2.3 Radiation Monitoring Systems

The information in this section of the ABWR DCD, including all subsections, tables, and figures, is incorporated by reference with the following departures.

STD DEP T1 2.3-1 (Figure 2.3.1)

Figure 2.3.1 Process Radiation Monitoring System Control Interface Diagram

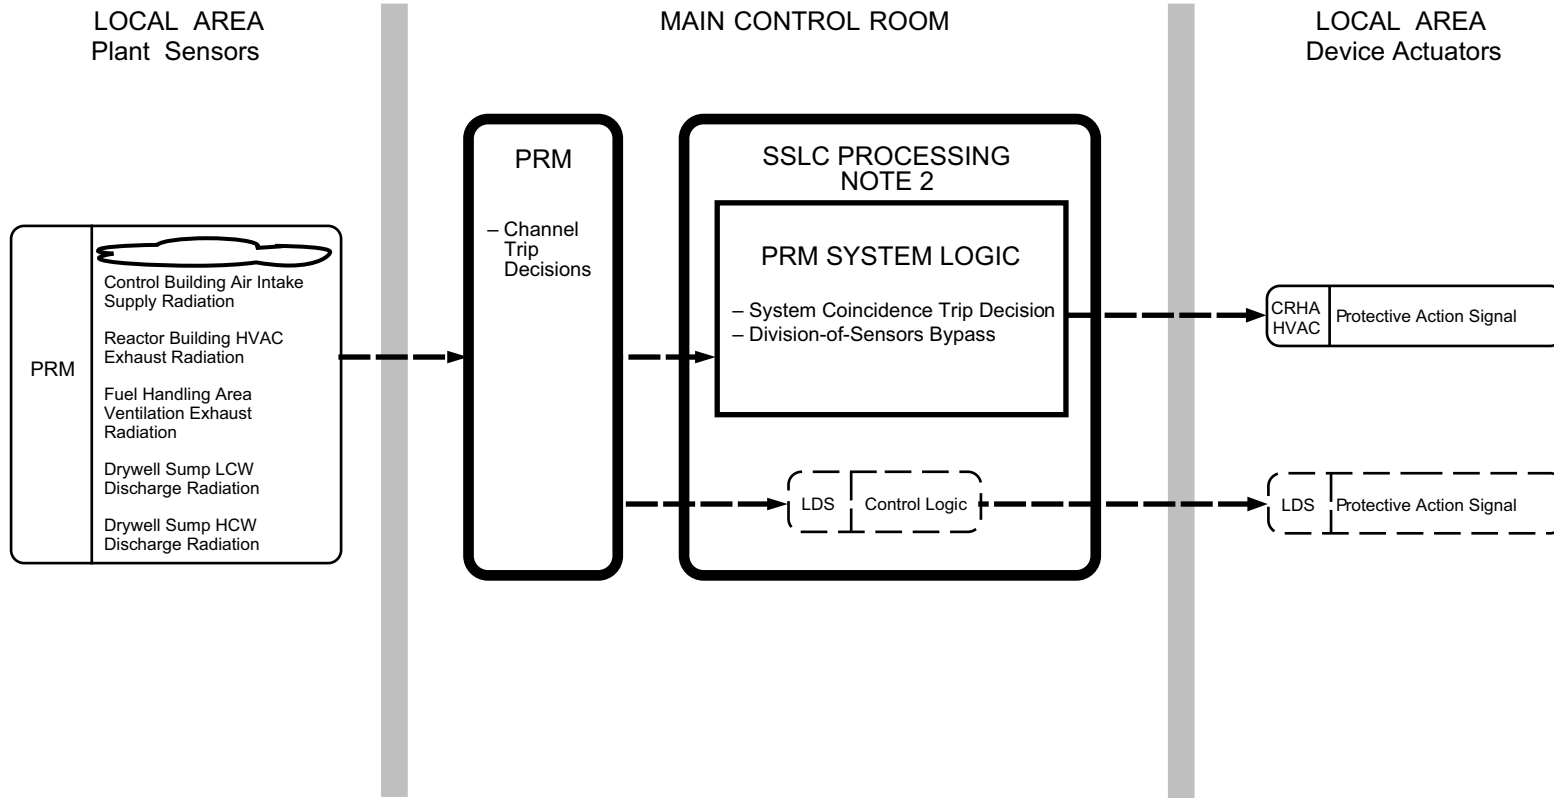
STD DEP T1 2.3-1

Portions of the PRM System are classified as Class 1E safety-related (items 42 through 5 below); the remainder are classified as non-safety-related.

- Notes:
1. Diagram represents one of four PRM System divisions.
 2. See Section 3.4, Figure 3.4b for SSLC processing.
